North Dakota Department of Transportation

ADDENDUM 1 – JOB 7

TO: All prospective bidders on project SU-3-982(031)035, NHU-3-019(044)155 & NHU-3-020(074)103, Job No. 7 scheduled for the October 14, 2016 bid opening.

Sixth Avenue NE
 Detour Paving Layout
 Sta. 626+17.55 to Sta. 630+57.55

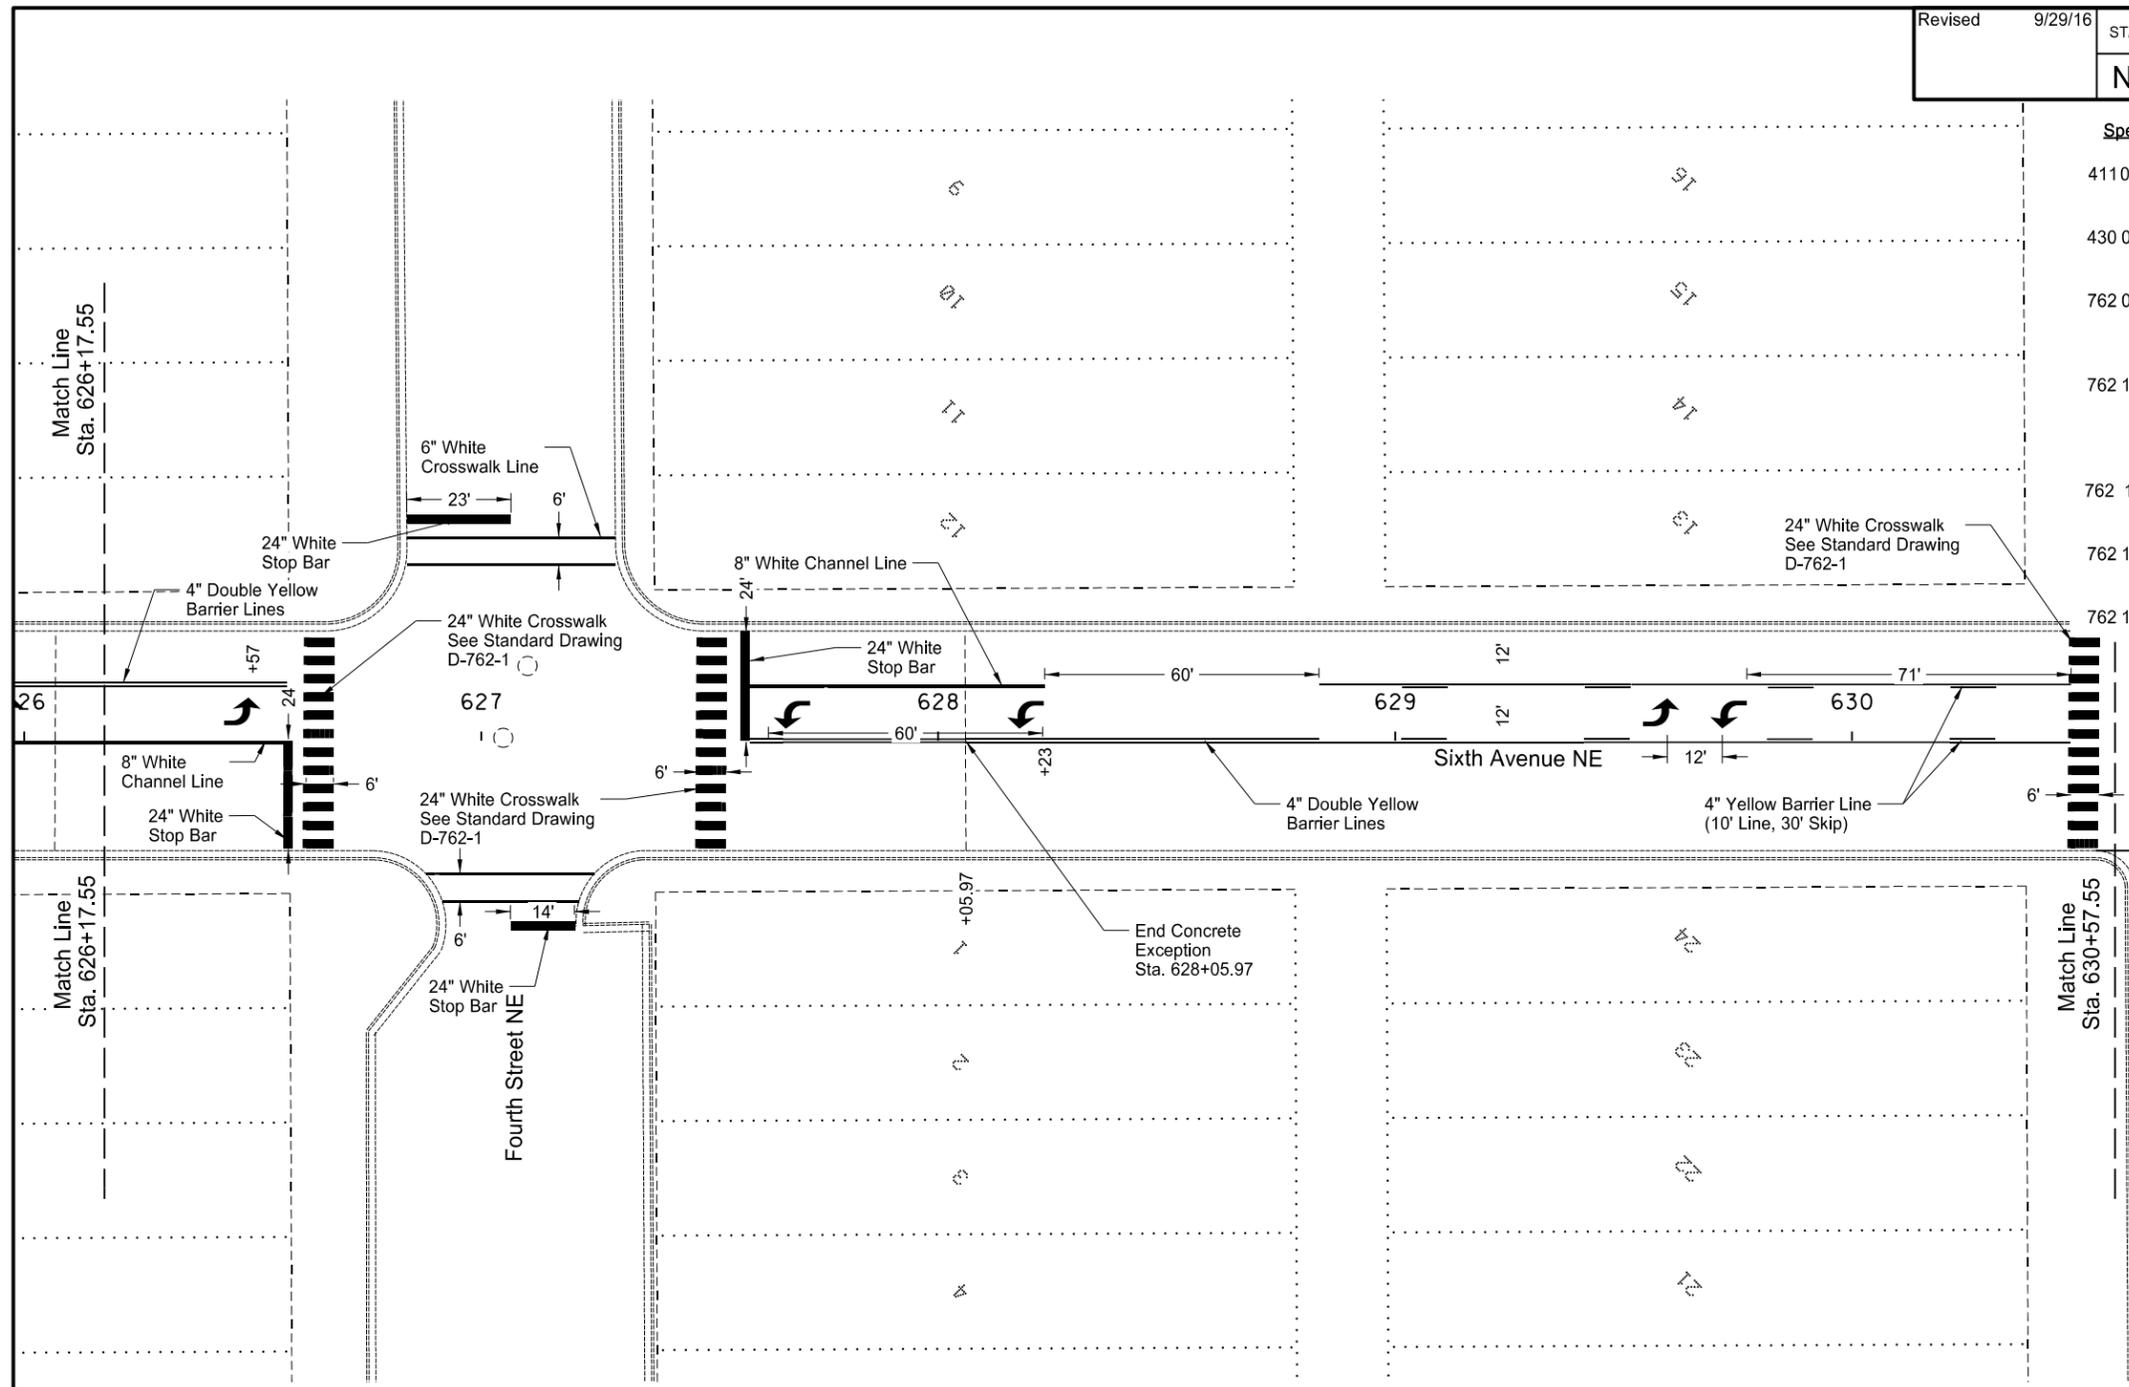
SHEET 15:

- Added pavement marking through concrete exception.
- **The following bid items have been updated: “Preformed Patterned PVMT MK-Message(Grooved)”, “Preformed Patterned PVMT MK 4IN Line-Grooved”, “Preformed Patterned PVMT MK 8IN Line-Grooved”,**
- **The following bid items have been added: “Preformed Patterned PVMT MK 6IN Line-Grooved”, “Preformed Patterned PVMT MK 24IN Line-Grooved”.**

ND Highway 20
Work Zone Traffic Control
Truck Detour

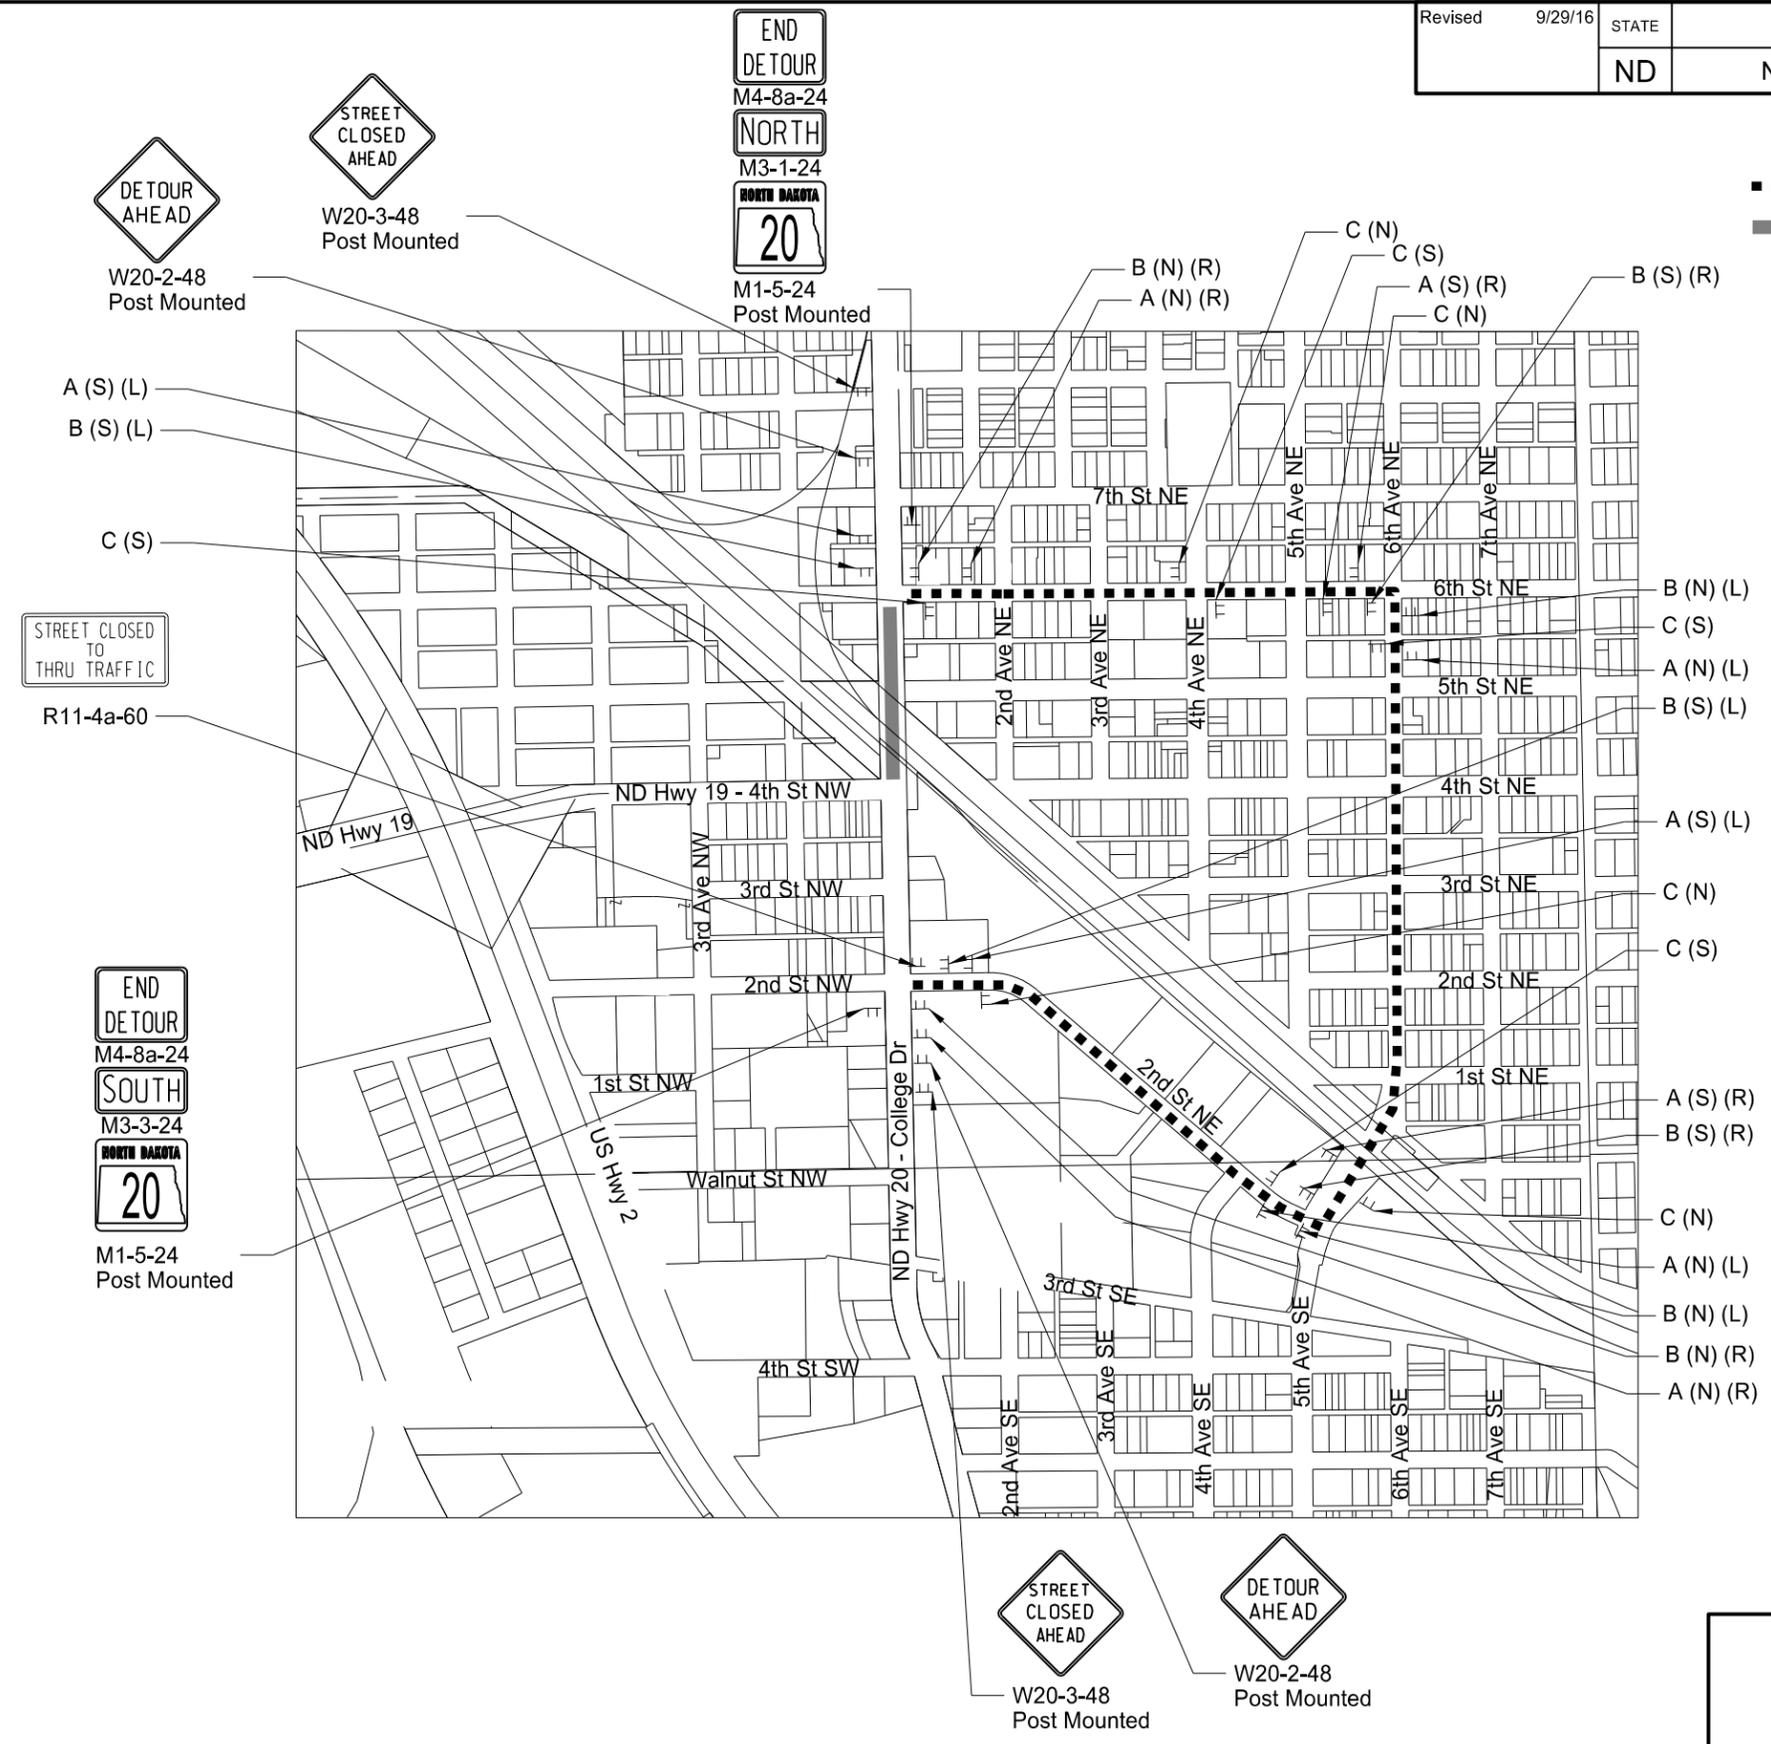
Deleted Under
Addendum 1

BNSF RAILWAY
1 MILE NORTH OF US 2
BNSF Ry. Br.0033-0085.600
SHOOFLY BRIDGE
GIRDER 1 ELEVATION

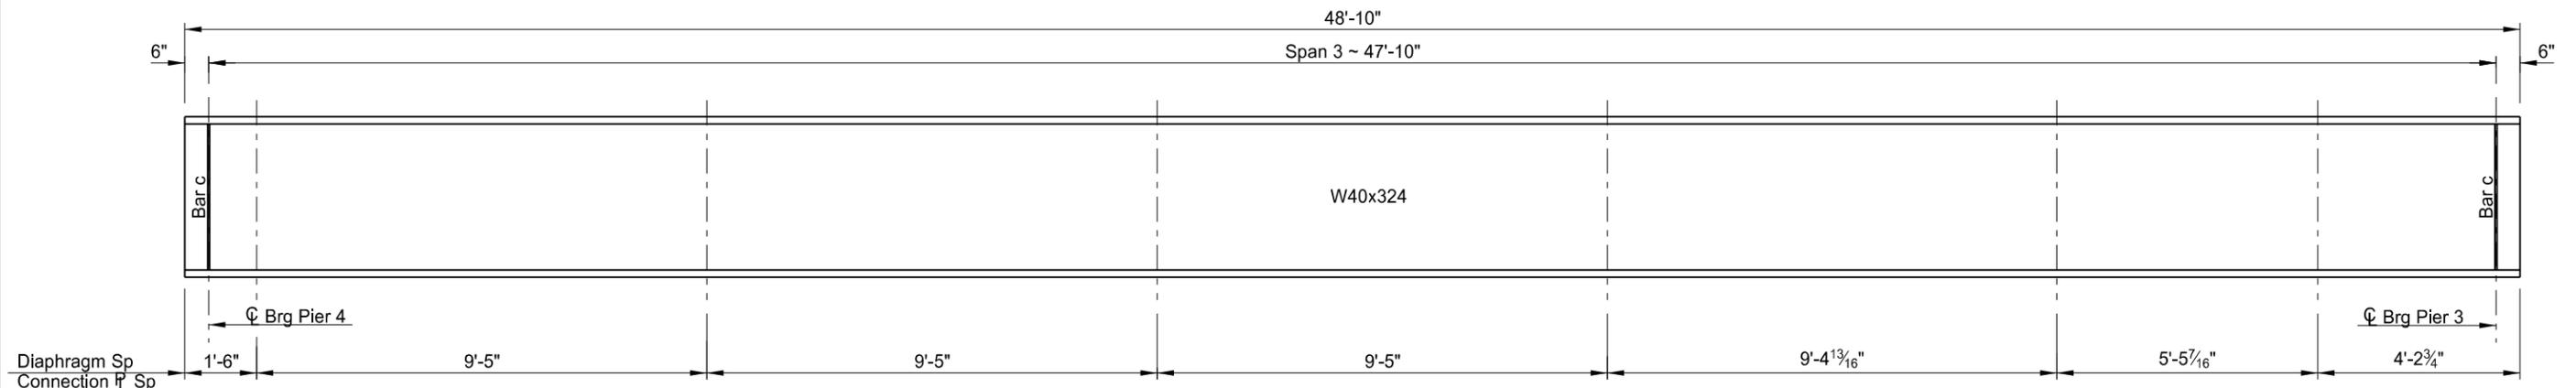
SHEET 32:

- Added Abutment Backwall, Abutment Bearing Seat and Abutment Footing callouts on Section at CL Bridge.

BNSF RAILWAY
1 MILE NORTH OF US 2
 BNSF Ry. Br.0033-0085.600
DISC BEARING DETAILS

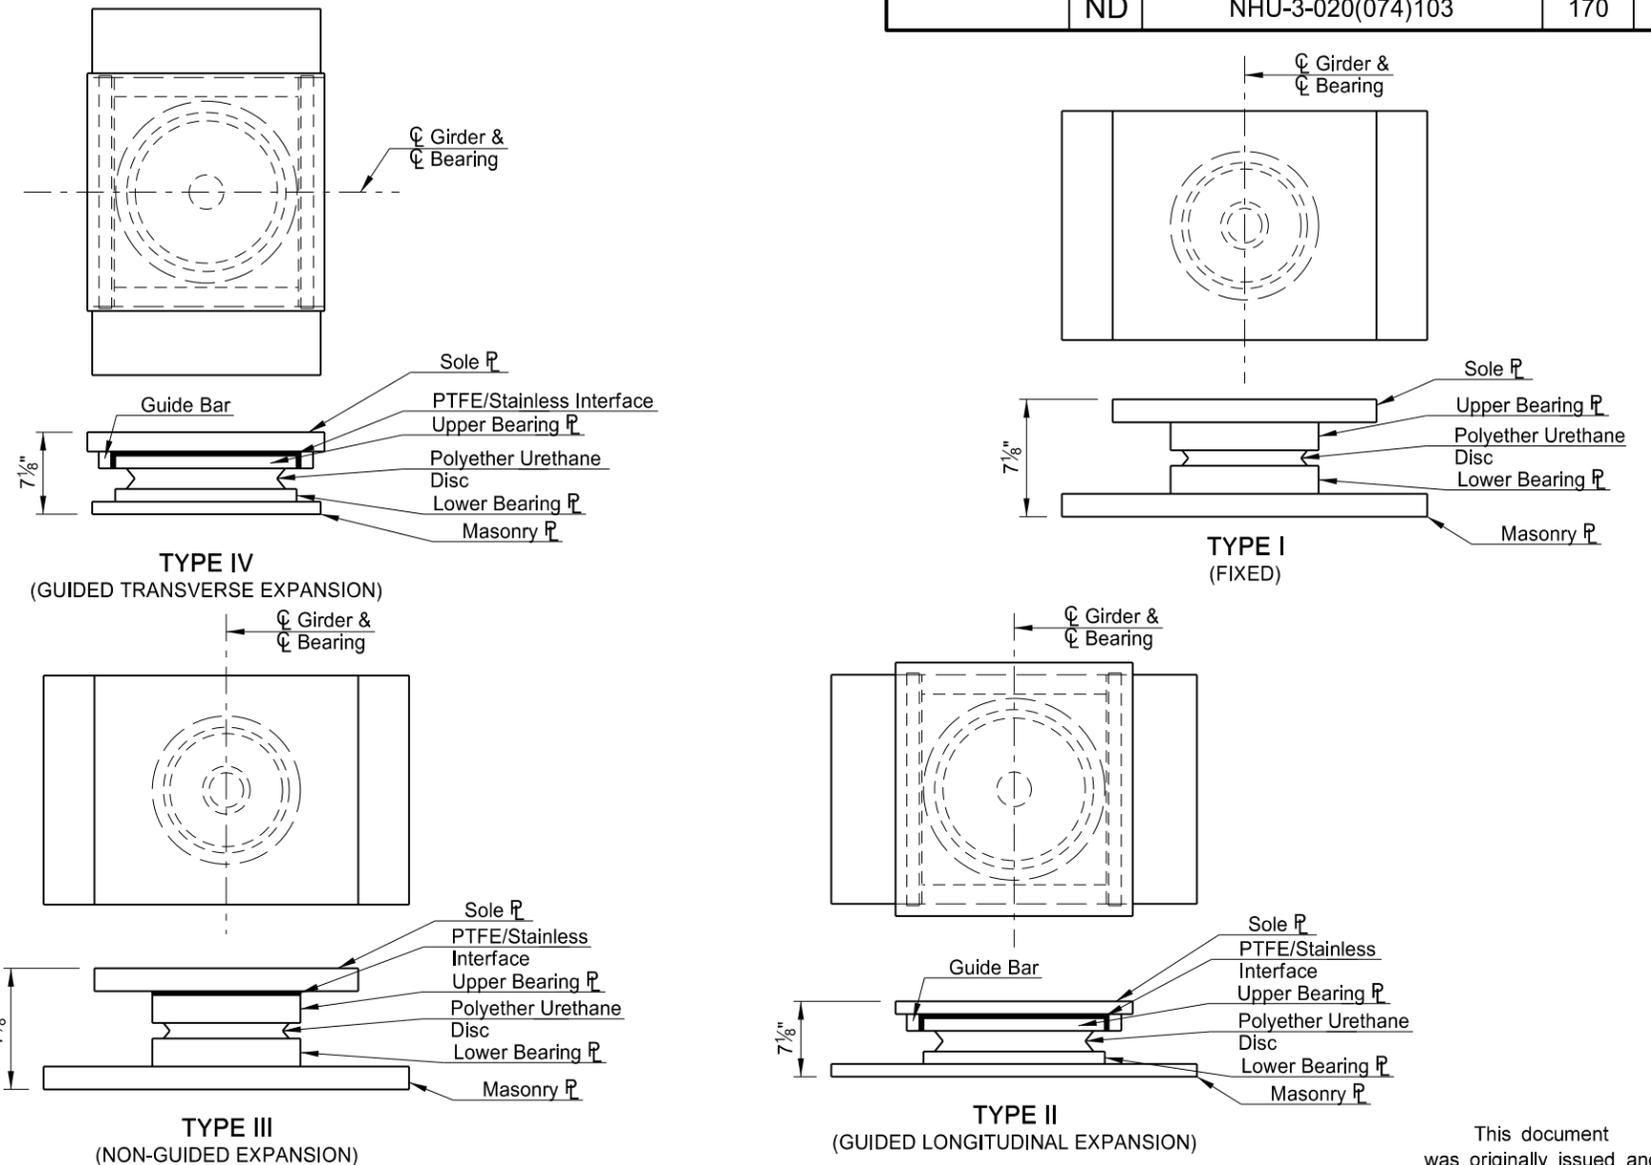
SHEET 47:

- Added minimum anchor bolt sizes in note 6.

INSIDE ELEVATION OF RAILING
(Showing Typical Dimensions)

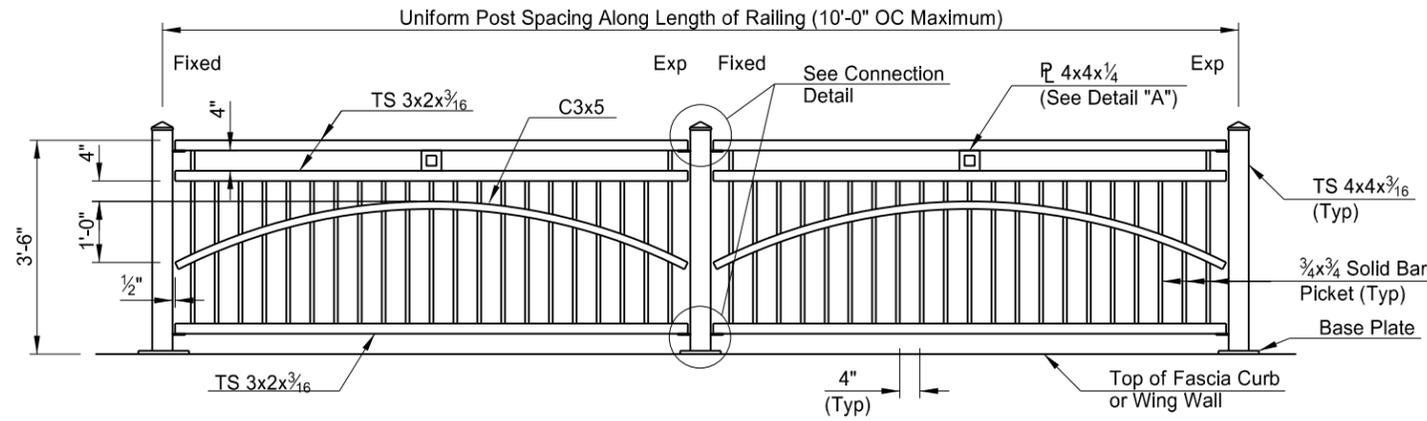
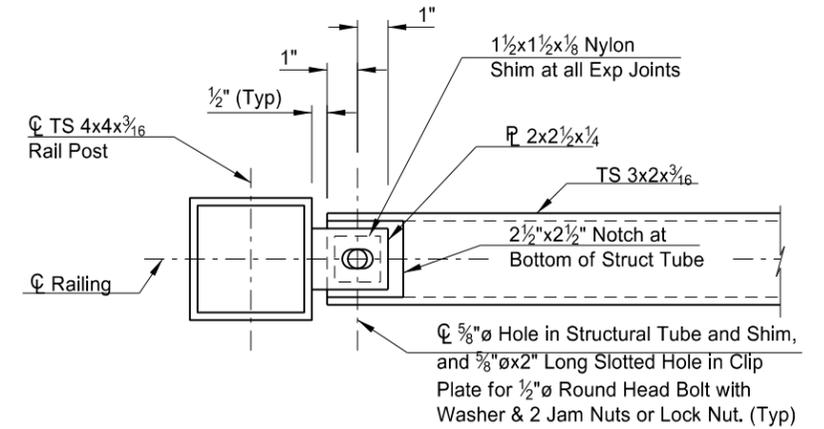
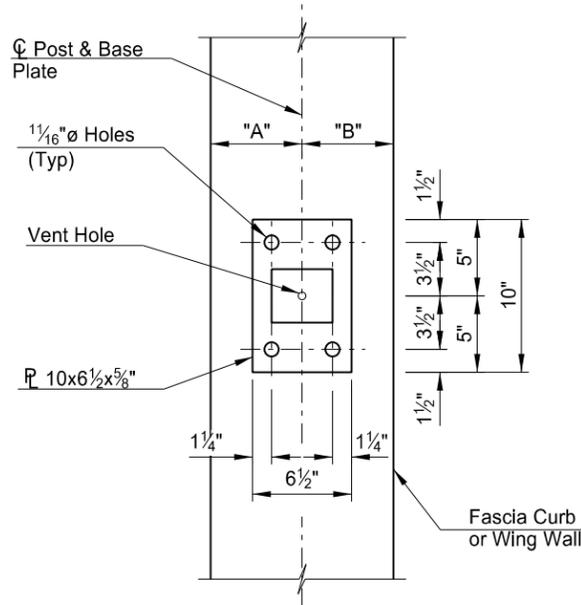
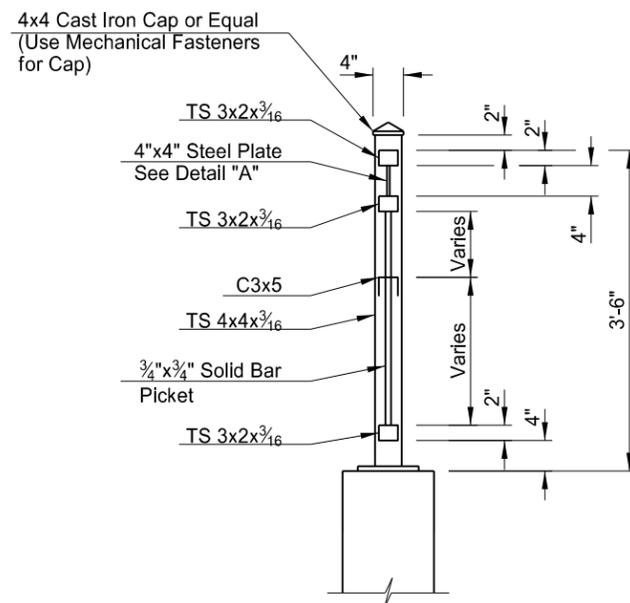
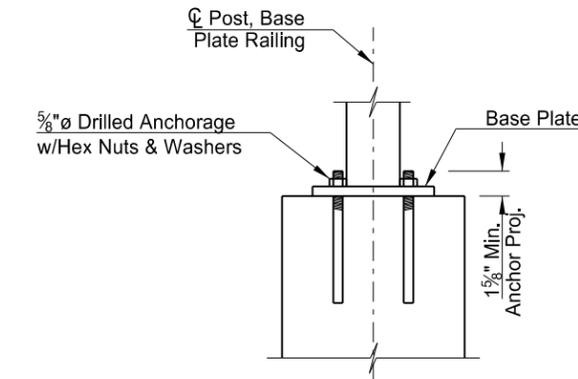
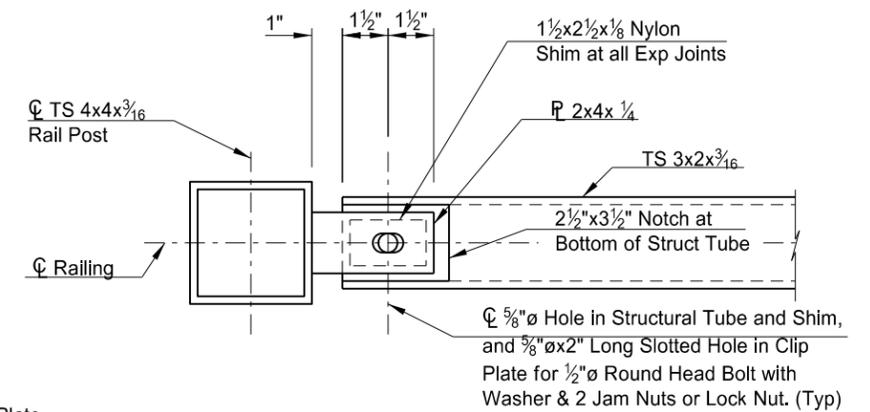
SHEET 69:

- **Added 4" spacing for the $\frac{3}{4}$ " pickets.**
